INSPECTOR'S EVALUATION AND OPINION - GEORGIA POWER COMPANY (EDWIN I. HATCH NO. I), LICENSE NO. CPPR-65, DOCKET NO. 50-321

REACTOR COOLANT PIPING  
VEPCO October 27-31, 1969

Feeder Report

WELD PREPARATION FOR STAINLESS STEEL PIPE  
 WITH CONSUMABLE INSERT, FROM WESTINGHOUSE  
 DRAWING 498 B 932

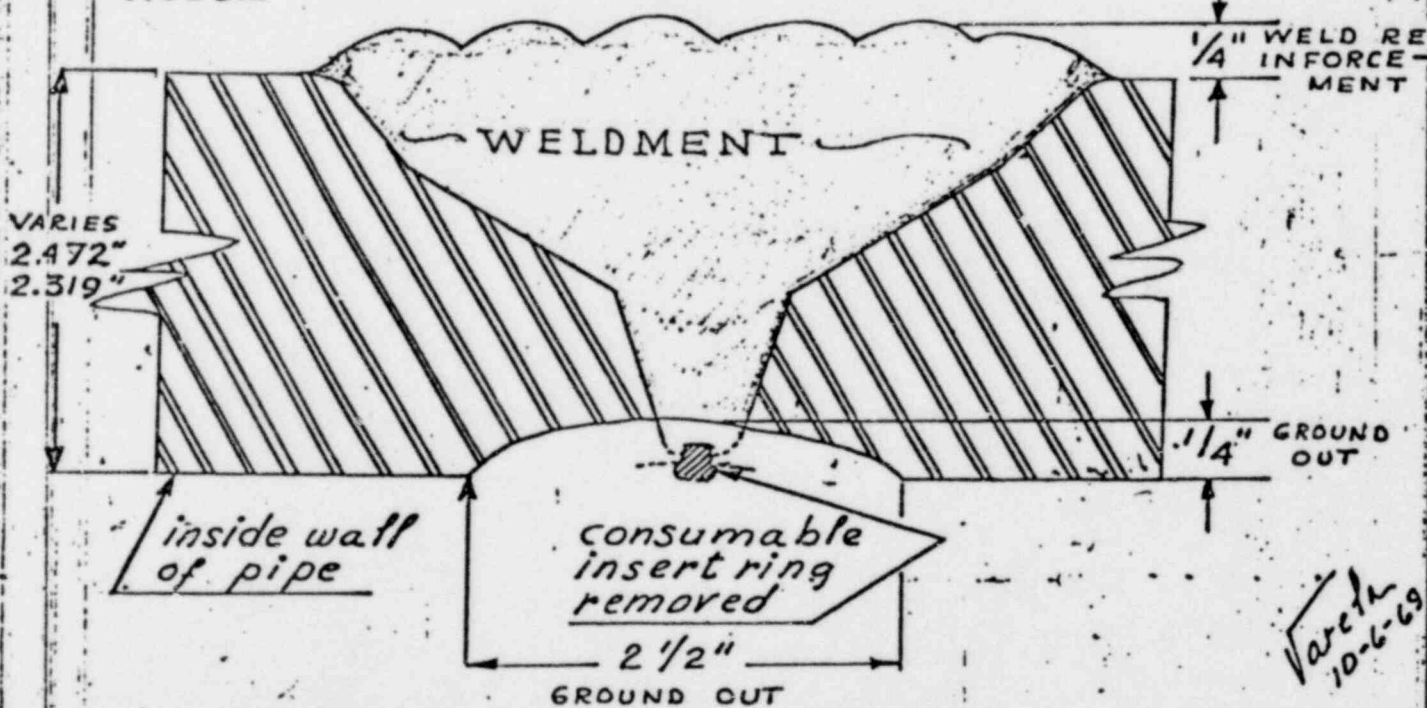
The inside of the butt weld of the straight pipe sections piece 7 loop 1 was ground out 2-1/2 inches wide and 1/4-inch deep. Three other similar spools were also ground out to approximately the same concavity. Exhibit No. 1 shows the concavity and the specified weld preparation. The extent of the grinding indicates that the grinding included ~~in~~ the removal of the consumable insert and indicates a defective TIG root pass which had to be removed. No repair was made and no deviation or ~~change~~ change request was noted on the source inspection report. Specification G676343 paragraph 1.1.2 "There shall be no deviation from this specification or its references without prior written approval of WAPD.

*THE WELD AREA DOES NOT CONFORM TO W DRWG 498B932 AS SHOWN ON EXHIBIT NO 2*

# AS-BUILT OF WELD TO SCALE.

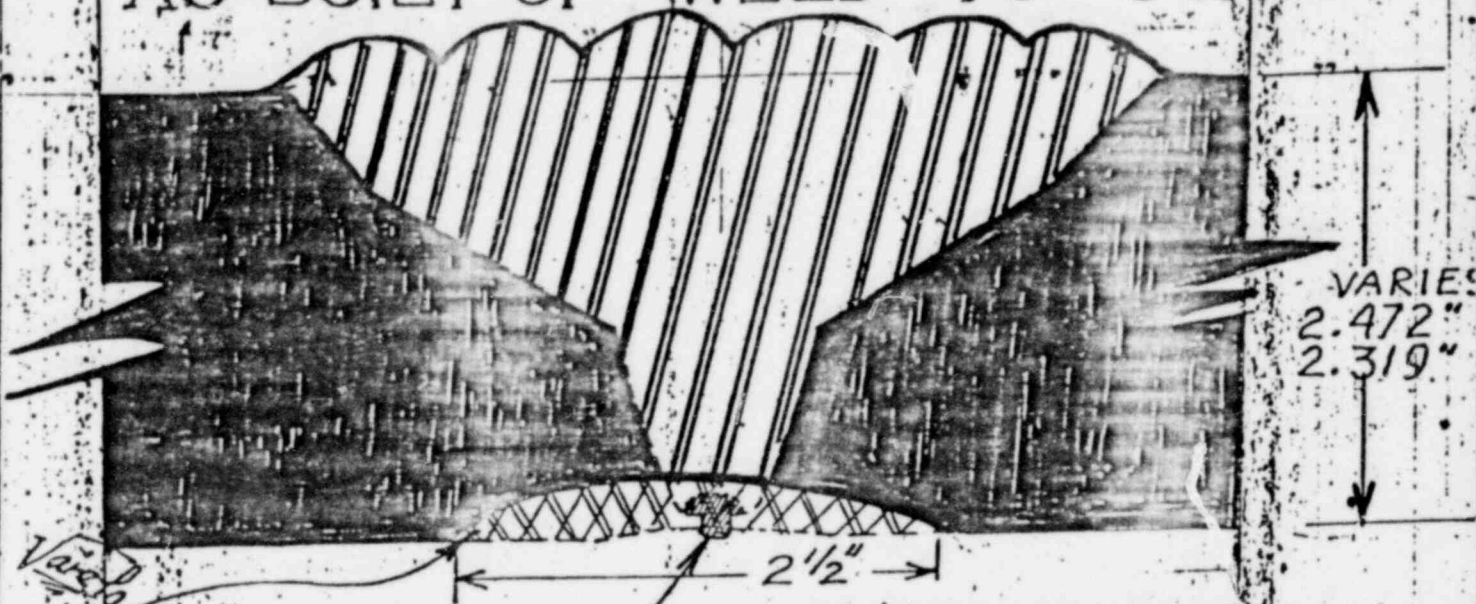
THE STRAIGHT SECTIONS OF PIPING WERE INCORRECTLY  
WELDED TO THE ELBOWS AS INDICATED BY THE COVER  
PASS WHICH WAS "STEPPED" AS SHOWN ON EXHIBIT  
2 AND PHOTOGRAPHY

BELOW IS 'AS-BUILT' OF LOOP NO.3, PIECE NO.7  
 MEASUREMENTS MADE WITH VERNIER CALIPER AND  
 DEPTH GAGE AND WITNESSED BY R. SAWYER OF WESTING-  
 HOUSE

LOWER SHADED AREA (2 1/2" LONG - 1/4" DEEP) WAS GROUND OUT
